Transport & Mobility Forum

Public Consultation – Response

Cork Area Commuter Rail

Preferred Option

Figure 1: M3 Parkway station / Dunboyne as illustration of how the catchment area of a station can be dramatically reduced by poor choice of its location

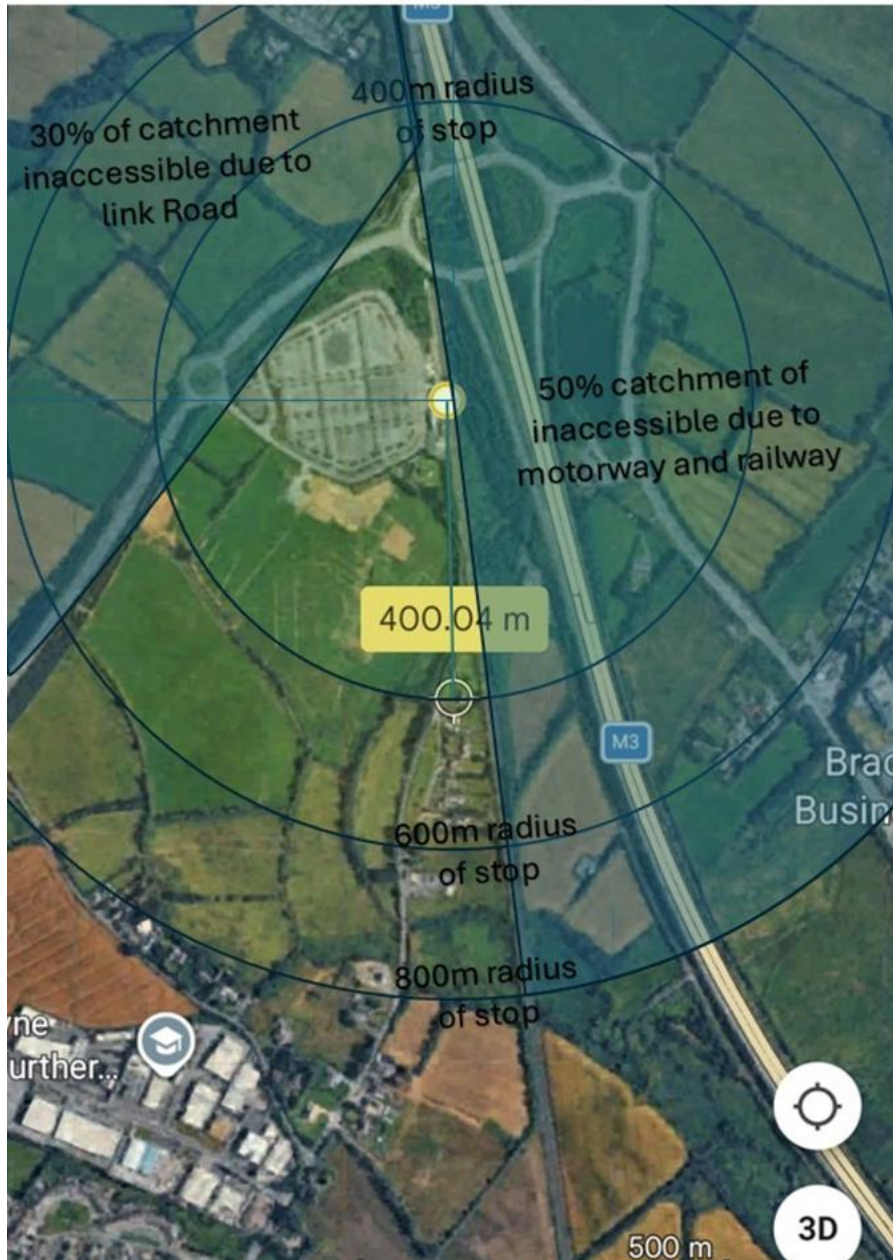
We are particularly concerned to avoid poor examples of the siting and access arrangement for newly constructed stations in Ireland which prevent the development of a residential or office space in close vicinity to the station hence severely limiting the population which can be served. For example, the M3 Parkway station outside Dunboyne, County Meath (which has its own station) is placed between the motorway and a limited access distributor road blocking pedestrian access from 3 sides and hence preventing any residential or commercial development to address the station.

In general, anything that blocks direct pedestrian access, or any low intensity uses such as parking, distributor roads, warehousing distribution etc. should be avoided within 800m of a station (i.e. the typical walking catchment). However, we acknowledge that there are some low intensity uses such as depots, sidings, and Park + Ride which must be located adjacent to
